PLAN SET · REVISION R5

Stand 15288

ADIPEC 2026 · Sinor Marine / Amphicos

Equipment and branding additions to the approved Amphicos booth, shown in 2D and 3D. Every addition is numbered A1–A7 and colour-coded. The booth structure and its dimensions are unchanged.

2D plan

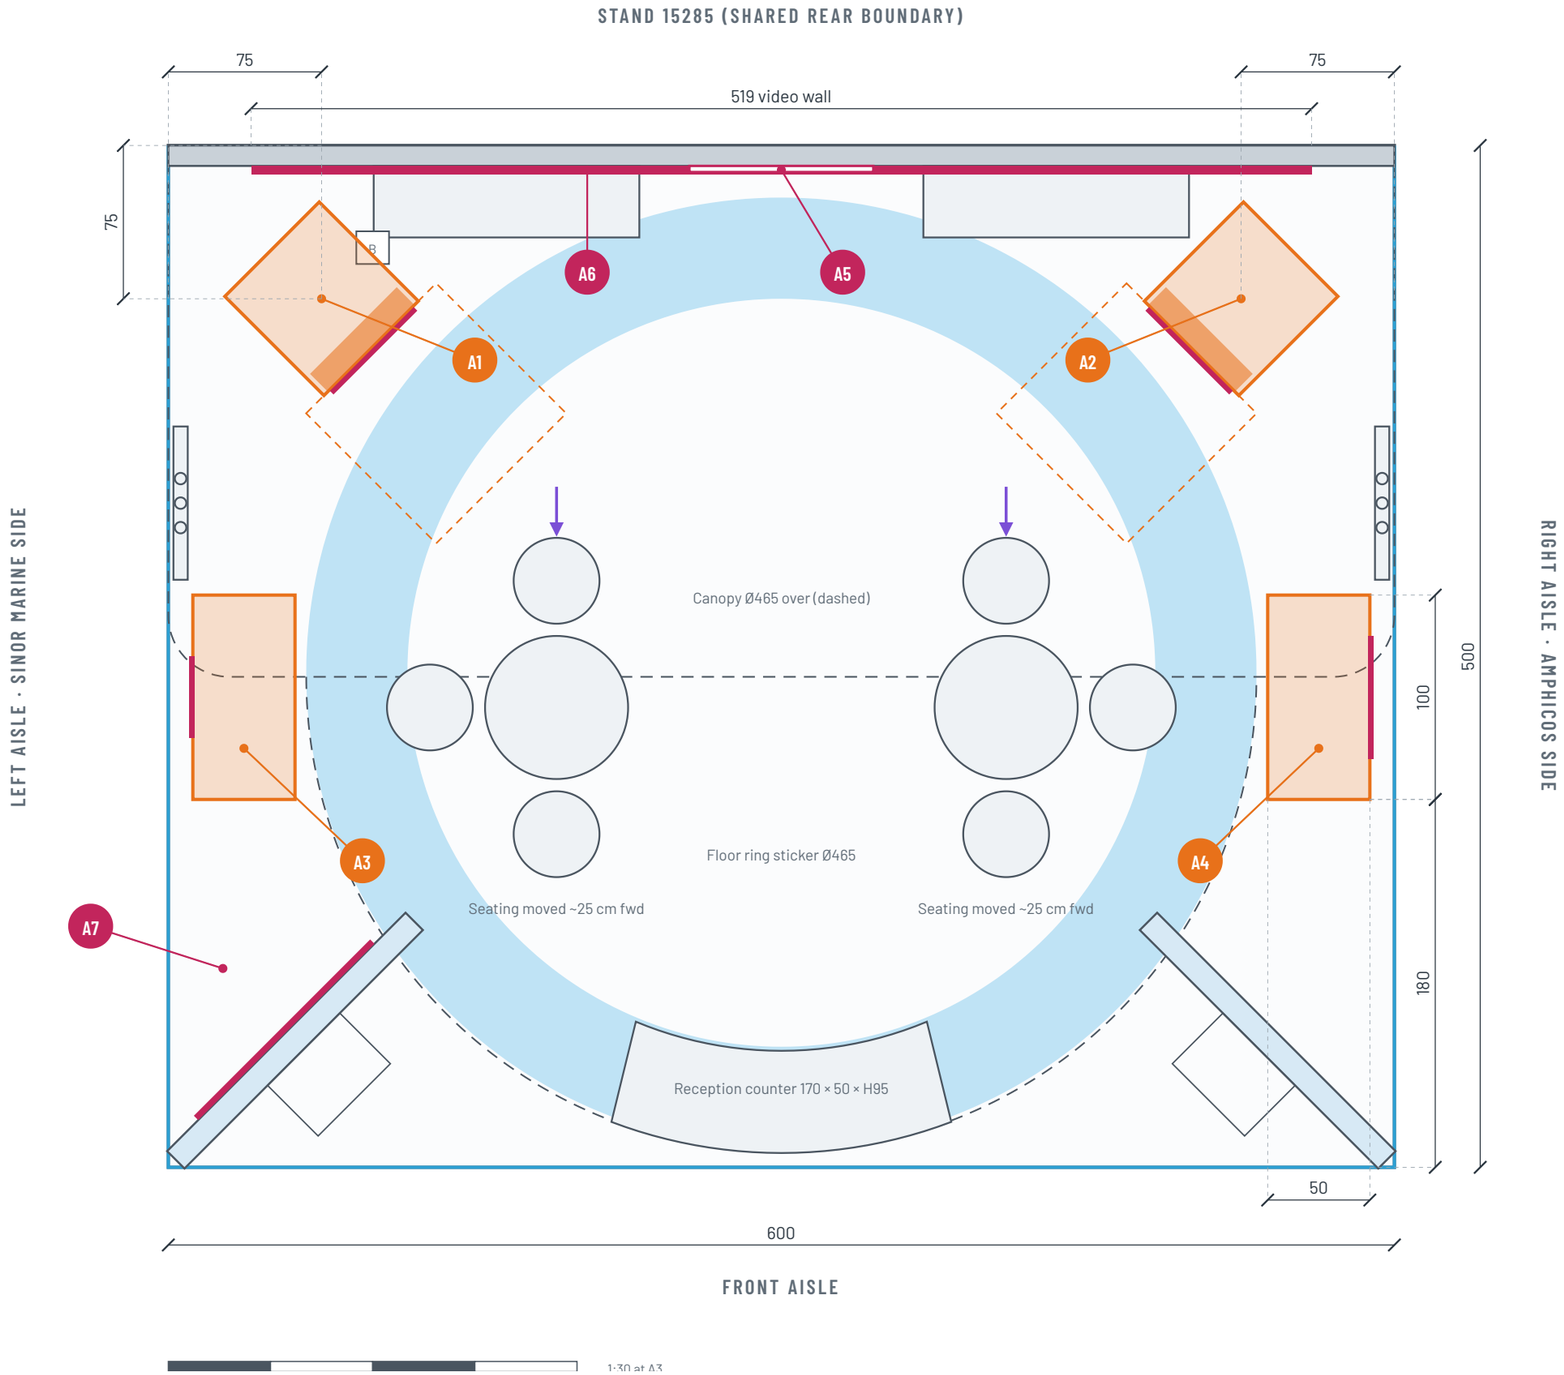
- **A1** MT DP console + MT logo fascia
- **A2** NAVIS DP console + NAVIS logo fascia
- **A3** Fugro Seastar 9410-AUT DGPS + monitoring display
- **A4** Sonardyne SPRINT-Nav DP in lockable cradle
- **A5** SMT logo (Sinor Marine Technologies)
- **A6** 8-screen video wall
- **A7** Partner Brands Showcase

- Two potted plants and two small rear side shelves removed (console corners)
- Seating groups moved ~25 cm forward, 3 chairs each, centre aisle clear
- SMT logo removed from the counter front (R2)
- Fugro / Sonardyne logos removed from the header corners (R3)
- MT / NAVIS hanging logos replaced by lit fascias on the console fronts, so the video wall is unobstructed (R5)

BACK WALL ELEVATION · from the front aisle · consoles shown dashed in front

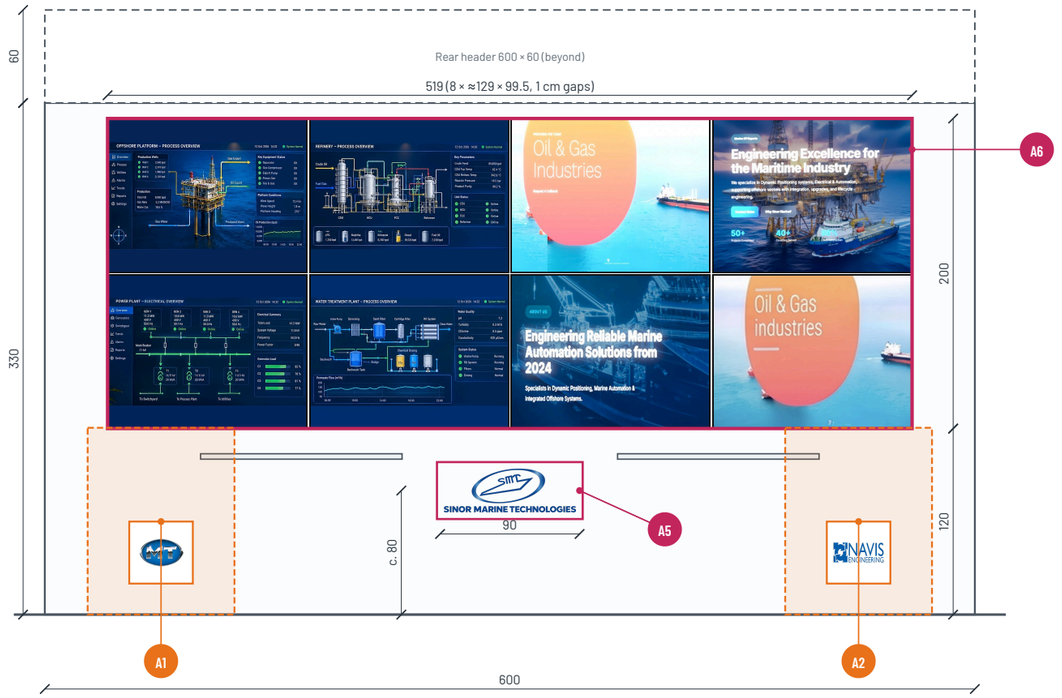
Box B on plan = DB B. All four equipment items fed from DB B (60 A, 3-phase) under the platform. Point A (15 A) is build-up only. MT and NAVIS consoles: 230 V, 10 A each (≈ 4.6 kW together), each on its own 16 A socket.

PARTNER BRANDS SHOWCASE

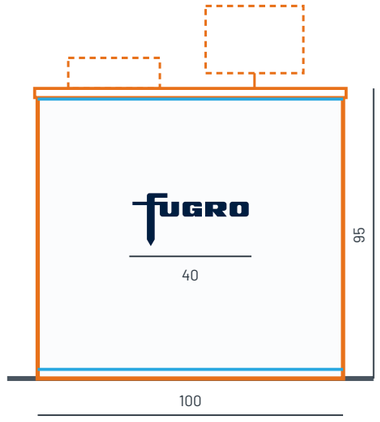
Sinor Marine frame, aisle face

FUGRO TABLE FRONT

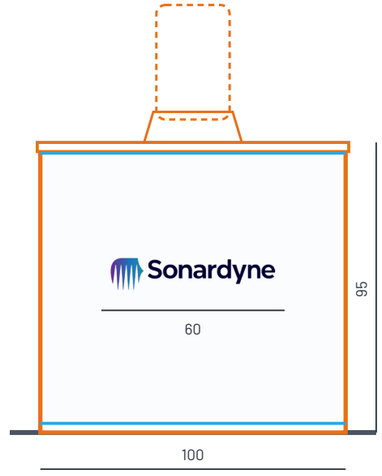
faces the left aisle · units dashed*
